# SERVICE BULLETIN

SB No. 83 Issue No. 1

**TITLE INSPECTION FOR FOUL BETWEEN NO.2 RUDDER PEDAL PAD PIVOT AND NOSEWHEEL STEERING ROD ARM**

FIG 1

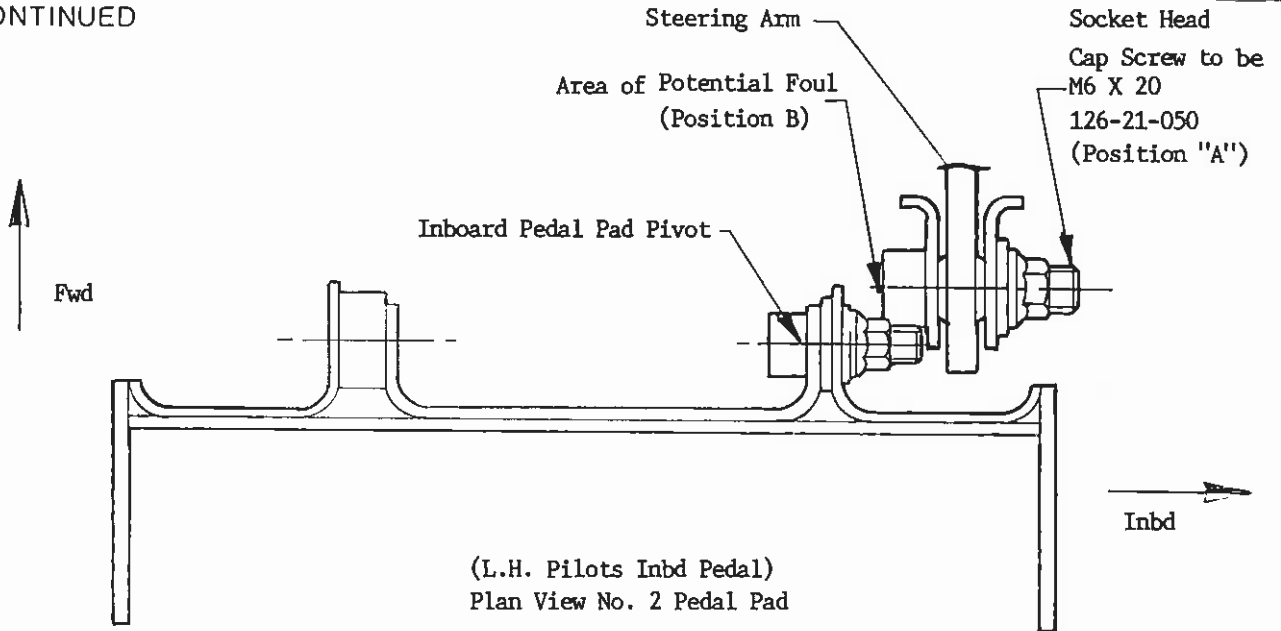
Cases have been reported during the build of the T-3A variant of the Firefly, of a potential foul between the No.2 pedal (left hand pilots inbd pedal) inboard pivot bolt tail and head of nosewheel steering rod arm attachment bolt.

This foul is to be found at extreme forward pedal adjustment full rudder deflection.

Additionally a case has been reported of a short bolt having been fitted at the nosewheel steering rod to arm attachment. The consequence of this is that the nut may not be properly locked.

1. At Position 'A', check that bolt at nosewheel steering rod arm attachment measured 20mm long measured from under head. If not replace with M6 x 20 126-21-050, Ref Fig. 1, orientated as shown.
2. At Position 'B', with No.2 pedal fully adjusted forward and with full right rudder check for clearance between bolt tail and bolt head Ref Fig. 1.

3. If 1mm or more clearance is shown with pedal mechanism on its stop together with correct rudder deflection with all backlash taken up to minimise the clearance, annotate in Log Book "SB 83 carried out".
4. If clearance is less than 1mm, or touching:
  - i) Replace existing socket head cap screw indicated on Fig. 1. With socket head cap screw 126-21-210 (or T67B-08-981) as shown in Fig. 2. Ensure correct rudder operation and deflections.
